ADDENDUM NUMBER ONE

PROJECT	BIDS DUE
GFA Project No: 10095 City of Clare 4 th and Beech Streets Streetscape & Park Improvements	Date: August 9, 2010 Time: 10:00 am Location: Gourdie-Fraser 123 West Front St. Traverse City, MI 49684

ADDENDUM NUMBER TWO

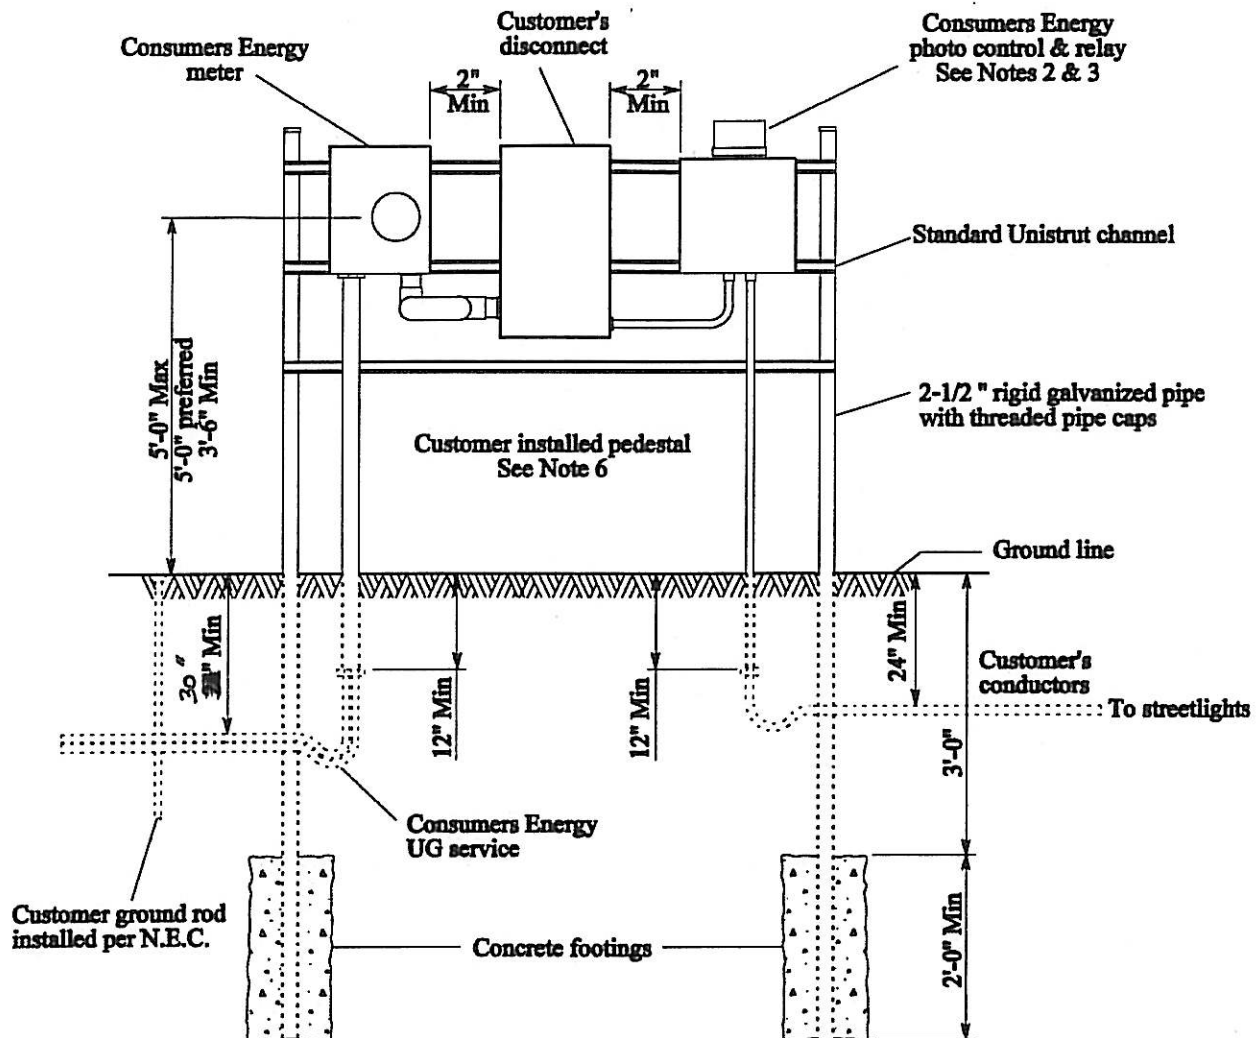
4. Bidders are instructed to replace the detail (5/7 Electrical Panel) shown on Sheet 7 with the attached detail provided by Consumer's Energy. Bidders are responsible for contacting Consumer's Energy to arrange for pick up of Consumer's Energy Supplied materials. All other materials and construction are the responsibility of the Bidder/Contractor.

1. Consumers Energy designates suitable point of attachment per Tariff Rule C1.6. Metering shall not be installed on Company poles.
2. Photo control and relay to be furnished by the Company and installed by the customer. Consumers Energy will own and maintain photo control and relay but all associated wiring and conduit is the customers responsibility.

3. Position photo control away from incoming vehicle headlights or other light sources.
4. Customer must have minimum of 10 streetlights in a clearly defined area per GML Tariff sheet No. D-46.00. Obtain approval from Standards when installing less than 10 streetlights per meter.

5. Conductors, other than grounds, installed 8 feet or less from ground line shall be covered with UL listed nonmetallic duct or molding.
6. Other types of metering pedestal require Standards approval. Pedestal location in road right of way and distance from curb follows same guidelines for structure placement as poles. Avoid creating a blind spot for motorists.

7. Installation of service equipment and wiring shall comply with National Electrical Code. All equipment to be of waterproof construction or enclosed in a weatherproof cabinet.

8. To prevent meter damage from conductor settling, earth beneath conductor should be well tamped and slack should be provided in the conductor at the riser.
